## V2500-A1/A5/D5 SERIES PROPULSION SYSTEMS SERVICE BULLETIN

This document transmits the Revision 1 to Service Bulletin V2500-ENG-75-0103 and the Revision 1 to the Supplement

# V2500-ENG-75-0103

ENGINE – LP TURBINE – ACTIVE CLEARANCE CONTROL C-TUBE WITH CHANGED MATERIAL FOR END  
FERRULES

Connector tube assembly – Replacement of sealing tubes  
Figure 2 (Sheet 3 of 5)

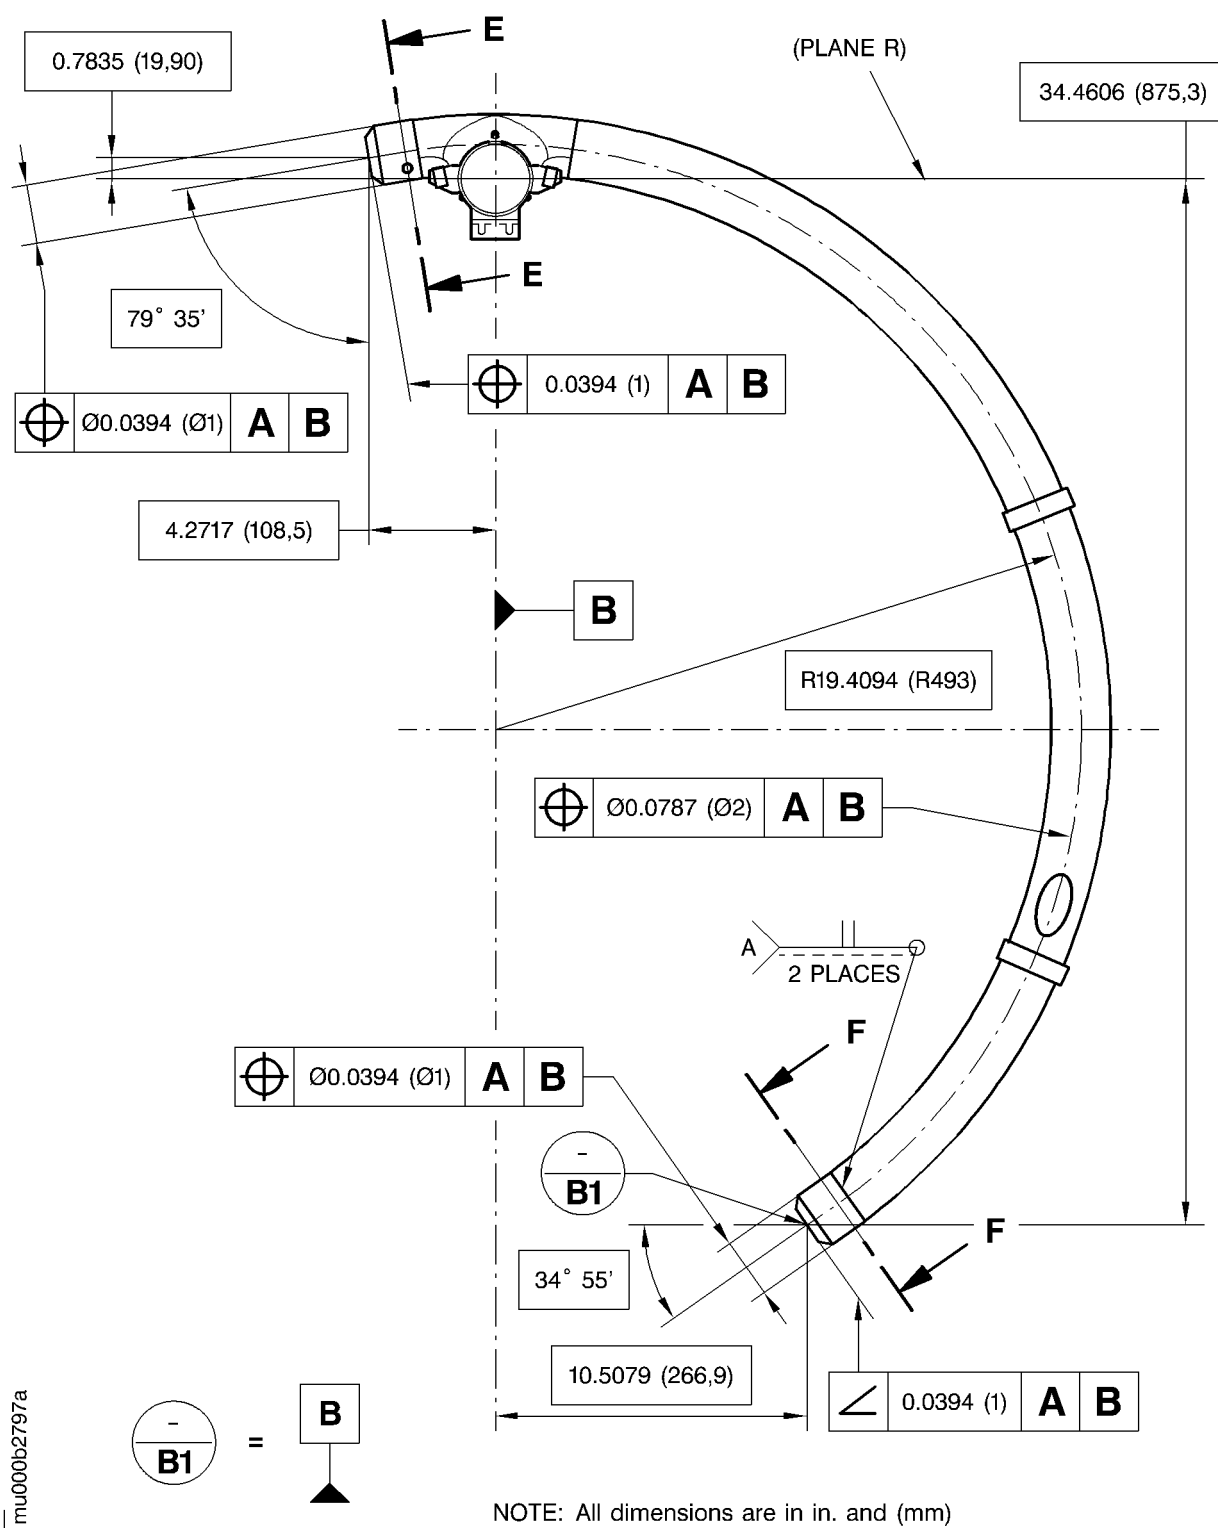
| (4) Examine the machined area   | Refer to Figure 2 (sheet 3 of 5). Use applicable inspection equipment.   |

Connector tube assembly – Replacement of sealing tubes  
Figure 2 (Sheet 4 of 5)

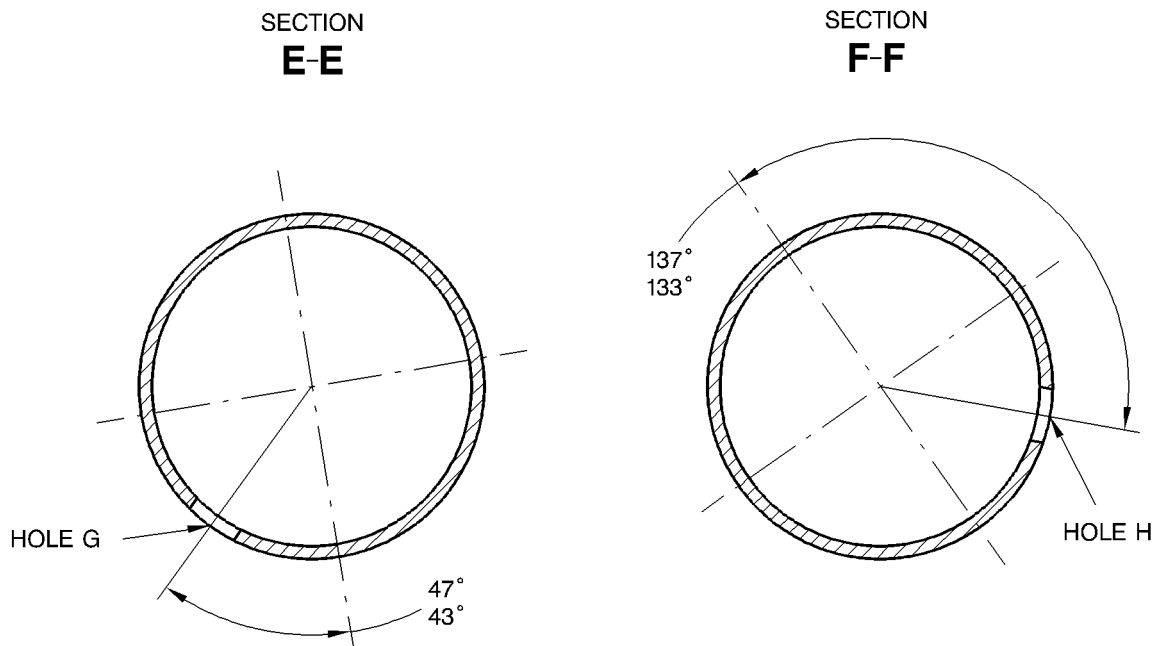
| (6) Weld in the replacement Sealing Tube (01-341) to the Connector Tube Assembly 01-010 | Refer to SPP TASK 70-31-13-310-501 and Figure 2 (sheet 4 of 5 and 5 of 5). Provide an argon gas backup. Flow argon gas into the tube during the weld repair. Weld in a protective atmosphere. Use CoMat 03-288 or 03-195 welding material and IAE 3M14523 cut off and welding fixture 1 off. |
| (8) Examine the welded areas dimensionally  | Refer to Figure 2 (sheet 4 of 5). Use applicable inspection equipment.   |
